ADDENDUM NO. 1

HC Wheatley Institute 3<sup>rd</sup> Floor

## **Project: Wheatley Institute – 3<sup>rd</sup> Floor Renovation**

### **ADDENDUM NO. 1**

**M9243**  
**G0.2**

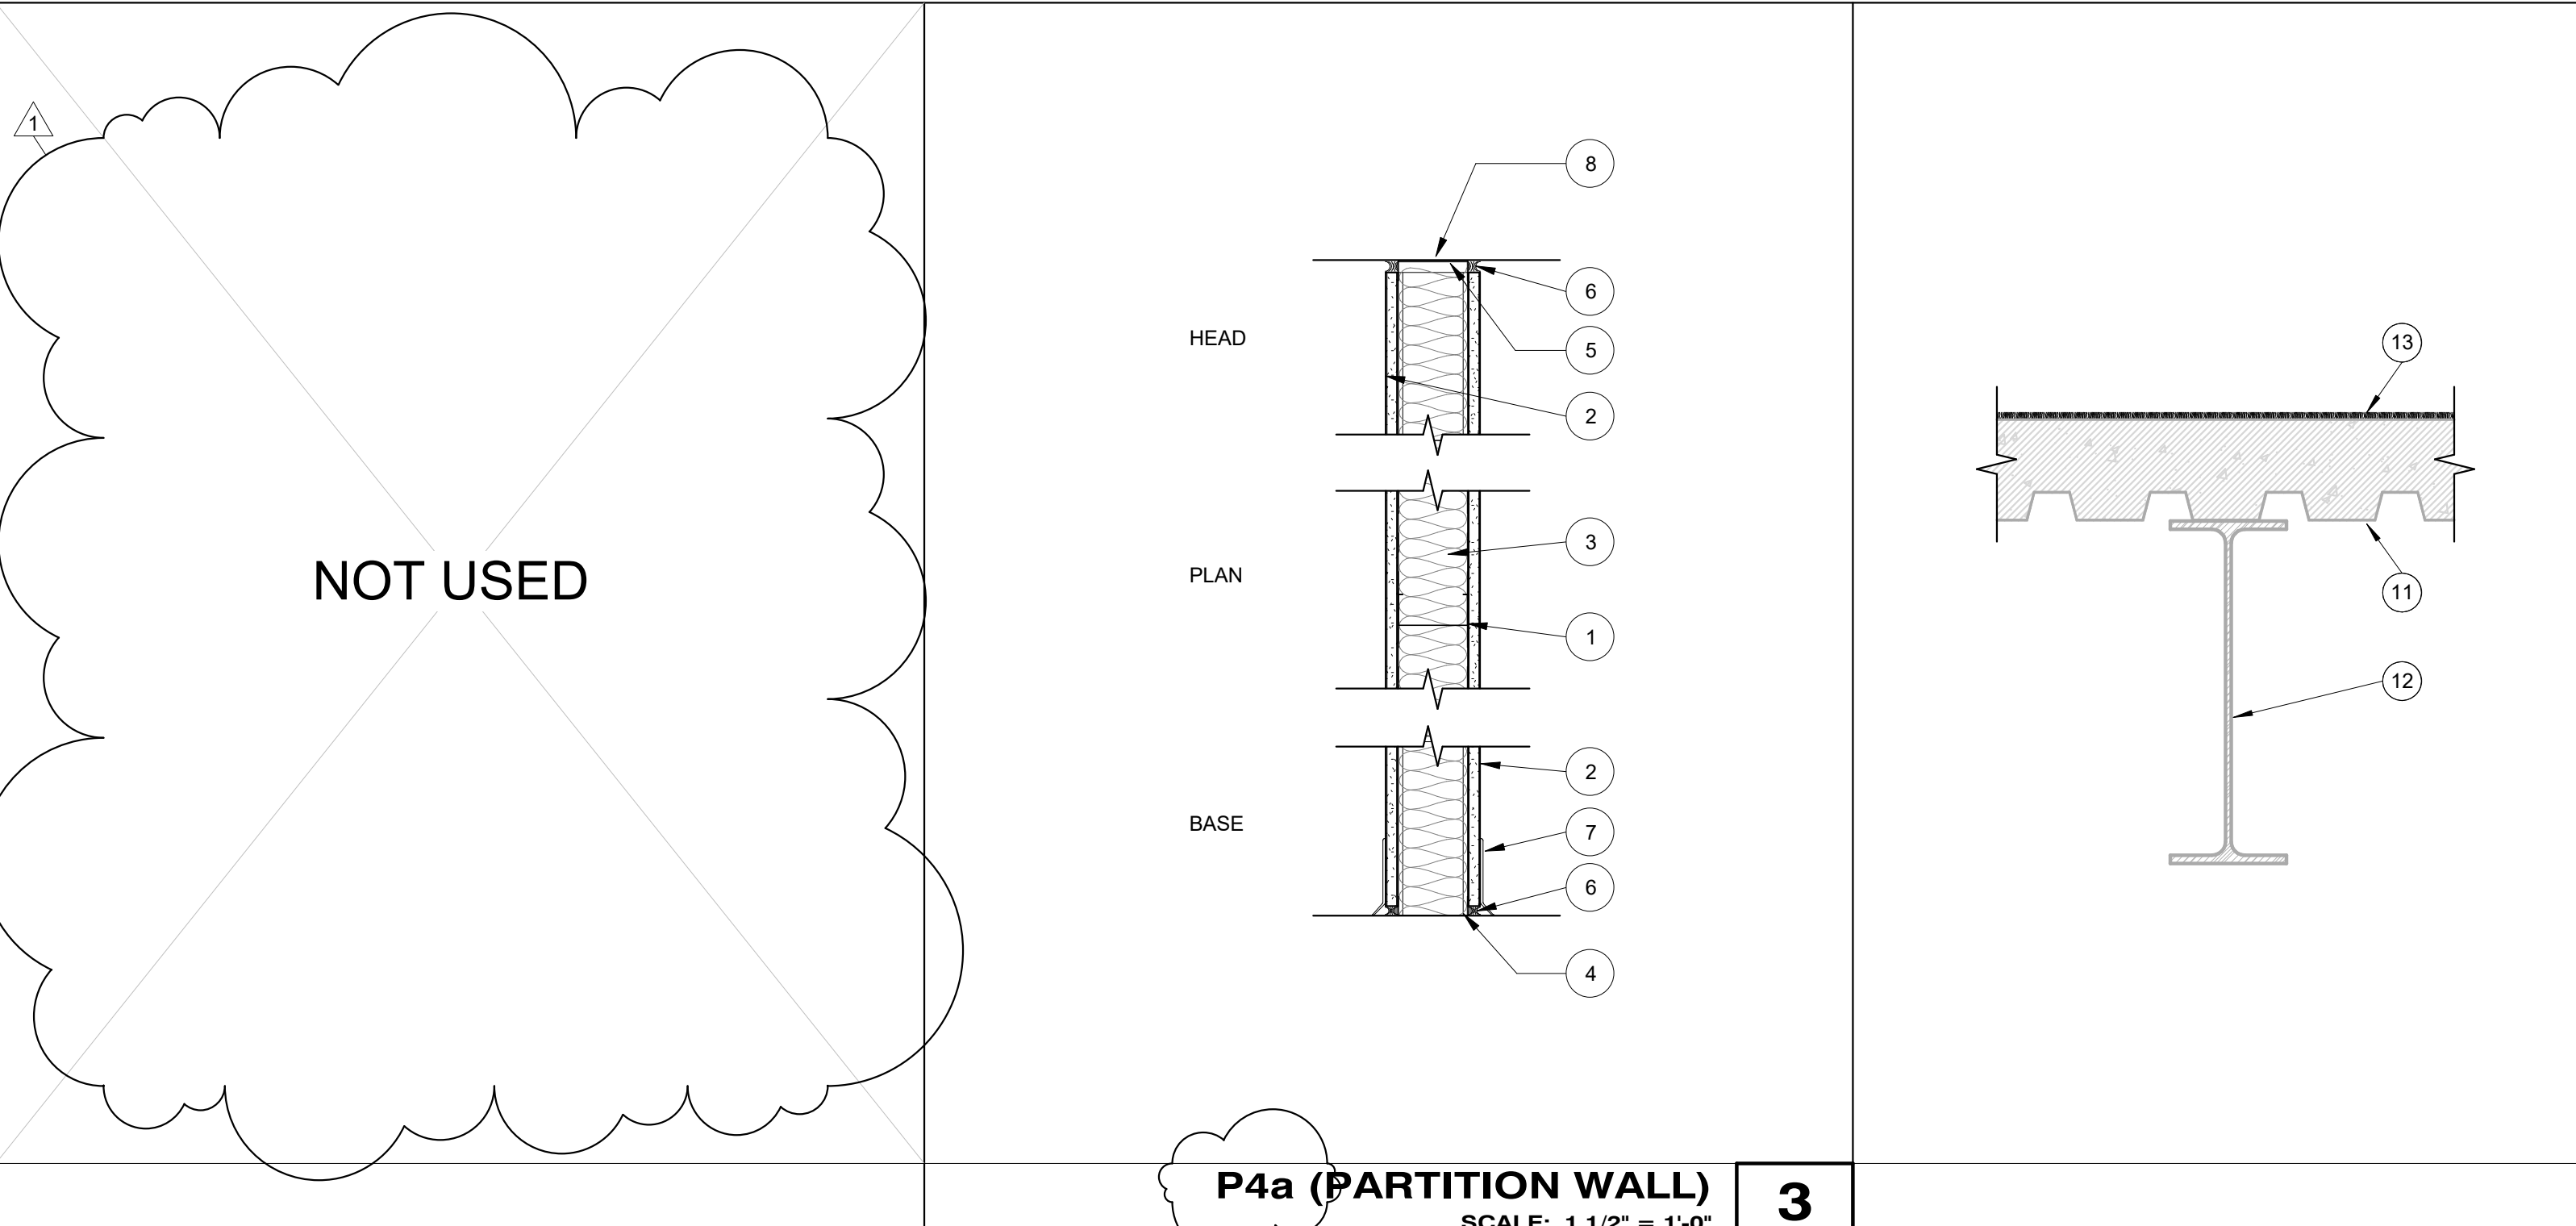
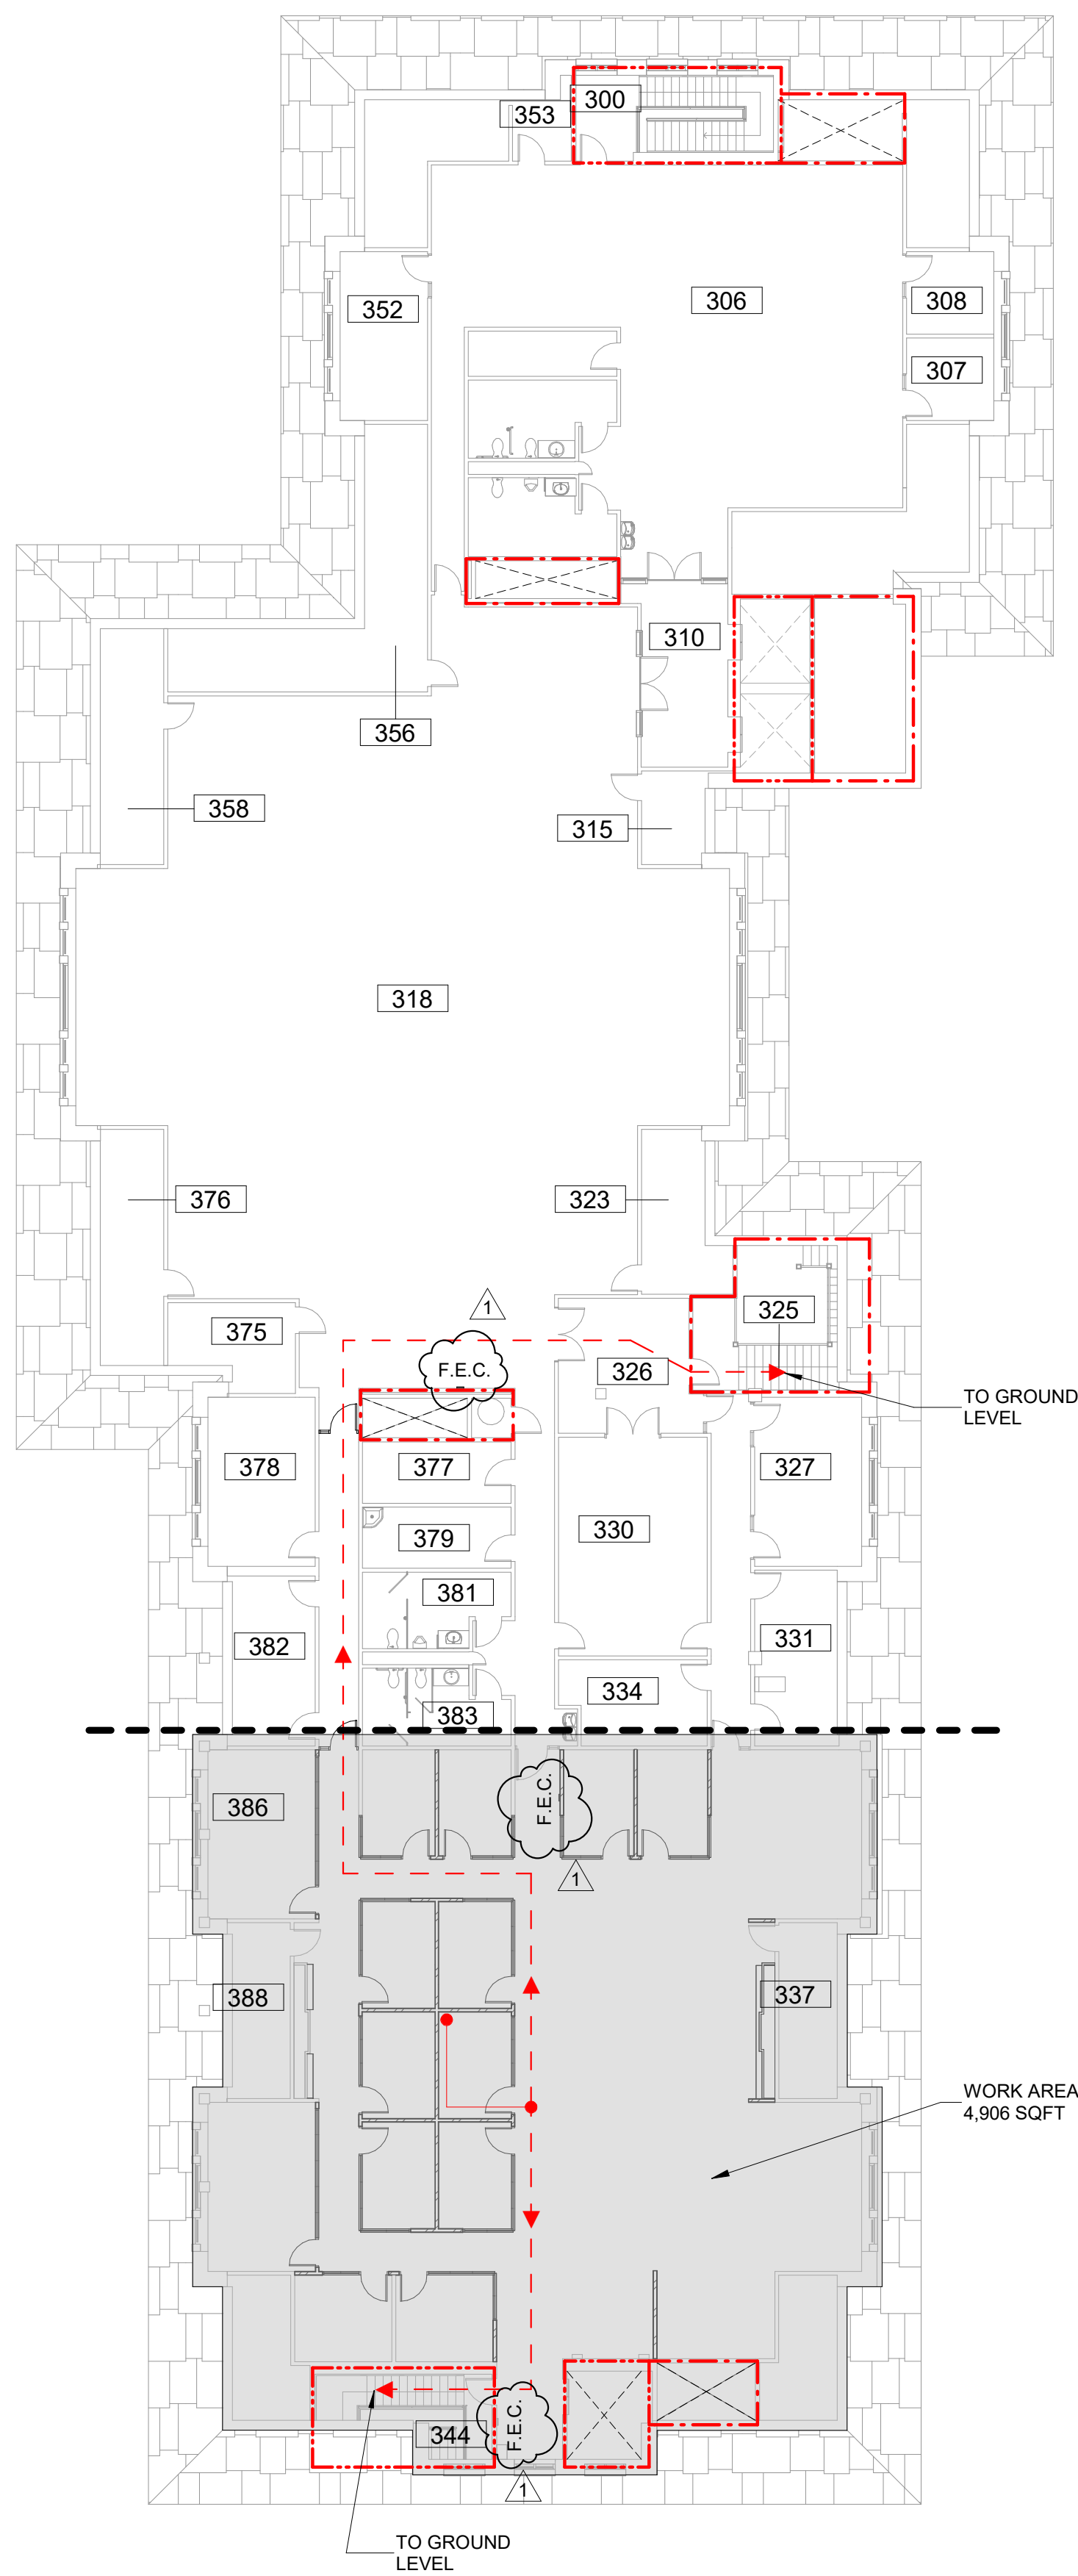
1. **Sheet G0.2**
  - REVISE: Responsibility Matrix.
  - REVISE: Reference Note 1 to include metal stud size.
  - REVISE: Detail 3 title to read P4a (in reference to stud size).

- REMOVE: Assembly type FR3a from sheet.
2. **Sheet G0.3**
  - REVISE: Detail 1 – M9243 Egress Plan to show locations of Fire Extinguisher Cabinet locations within general vicinity of work area.
